Product Change Notification (PCN)

- 1. Micro SD Card 47352xxxx HSG modifies product structure to improve warpage
- 2. Micro SD Card 47352xxxx HSG materials change from LCP E471i to LCP E481i;

PCN #	Molex Part #
508651	473521001

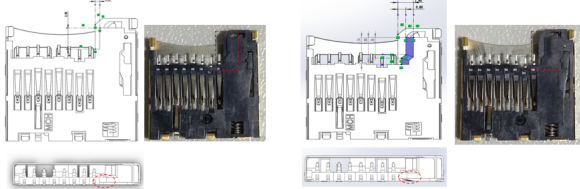
- 1. Micro SD Card 47352xxxx HSG modifies product structure to improve warpage
- 2. Micro SD Card 47352xxxx HSG materials change from LCP E471i to LCP E481i;
- 3. Appearance contrast is not obvious.
- 4. Change reason :
 - a. Improvement of Warpage Deformation.
- Product Impact
 - No impact to fit, form or function
- Part Number Impact
